# Access Compliance Report

### (Curb Ramps)

| Intersection ID: 25815                  | Main Street: REA_RD | Cross Street: PINEVILLE-MATTHEWS_RD     | Location: SE           |
| ADA ID: 2DFEE19702EF                    | Ramp Type: Perp     | Initial Pass/Fail: Fail                 | Overall Compliance: No |

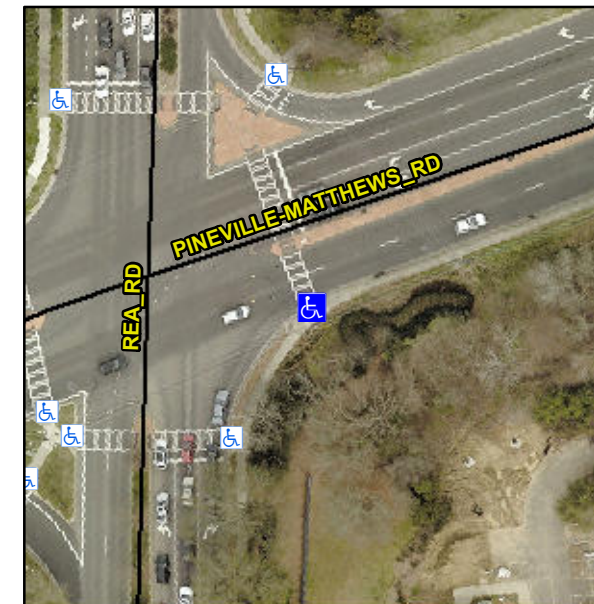
**Not Found, R304.2.2**

| Compliance | Description           | Data | Compliance | Description                 | Data |
|------------|-----------------------|------|------------|-----------------------------|------|
| N/A        | Ramp Length (in)      | 45.0 | No         | Ramp Slope (%)              | 8.9  |

**Remove & Replace Entire Ramp.**
